DEVIATION REQUEST AND DECISION FORM

Project Name : HAVEN VALLEY
Schedule No.(s) : 6512200001
Legal Description : ELY 780 FT OF N2NW4NW4 SEC 12-15-66

A deviation from the standards of or in Appendix F detail SD4-1 of the Engineering Criteria Manual (ECM) is requested.

TYPICAL PRIVATE STREET SECTION
(URBAN LOCAL-LOW VOLUME)

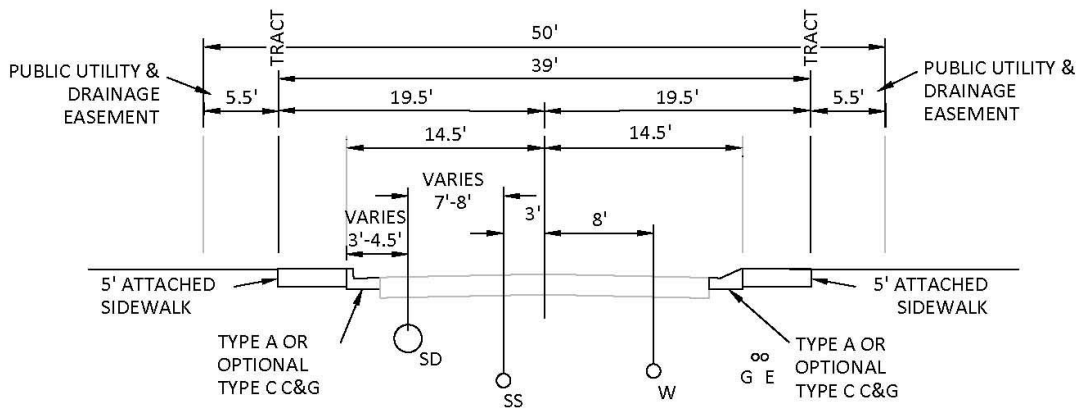
This deviation is a request for approval of a 3'-4.5' distance between center of storm drain to top back of curb within this project site. The cross section for the roadways is 29' from top back of curb to top back of curb. The water line has been placed 4'-4.5' from the center to the lip of gutter. The sanitary line has been placed 11' from the center of the water to the center of the sanitary line. The storm has been placed 7'-8' from the center of the sanitary to the center of the storm. This leaves 0.5'-2' from the center of the storm to the lip of gutter.

The proposed streets and storm sewer within this project site are private and it will be the responsibility of the HOA to maintain the roads and curb. The HOA will also be responsible for replacing any damaged curb & gutter resulting from their decision to place the storm drain with less separation from the curb. The ECM standard is 6' from center of storm drain to top back of curb. The proposed alternative is 3'-4.5' from center of storm drain to top back of curb.

This request has been determined to have met the criteria for approval. A deviation from Section SD 4.1 of the ECM is hereby granted based on the justification provided.
